SITE PLAN REVIEW

LOT NO. 77..... REGISTERED PLAN
 THE PROPOSED LOT GRADING AND DRAINAGE IS APPROVED
 AS BEING IN CONFORMITY WITH THE OVERALL APPROVED
 GRADING PLANS FOR THE SUBDIVISION.

PROJECT/LOCATION
NORTHGLEN PHASE 2
CLARINGTON, ONTARIO

DRAWING
SITE GRADING PLAN

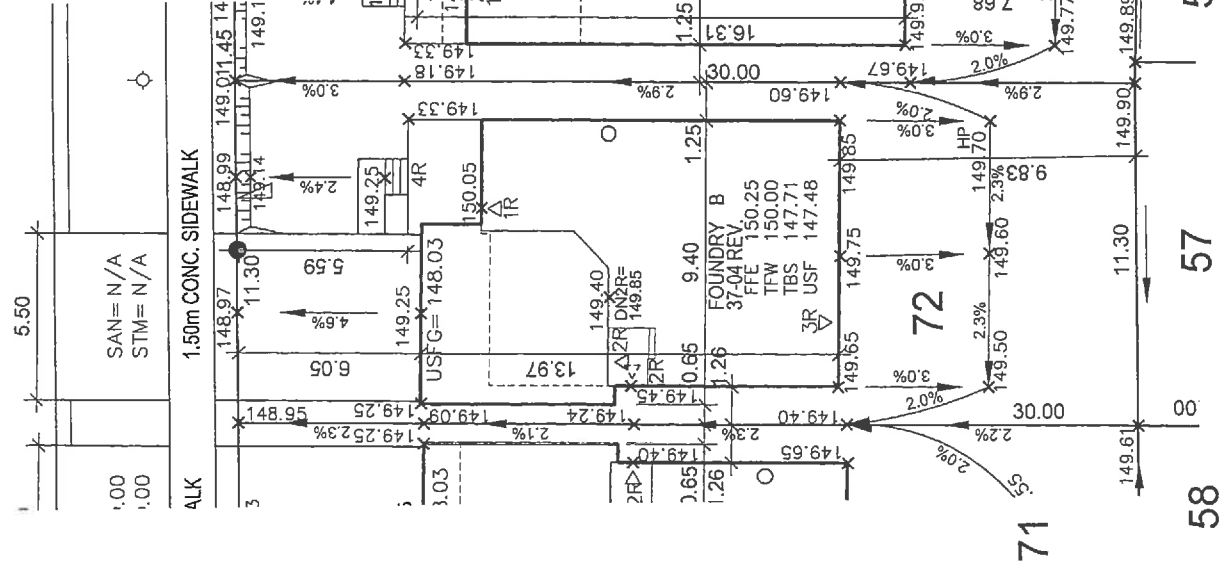
NO COMMENT ☒ REVIEWED BY
COMMENTS AS NOTED ☐ DATE Dec 7, 2015
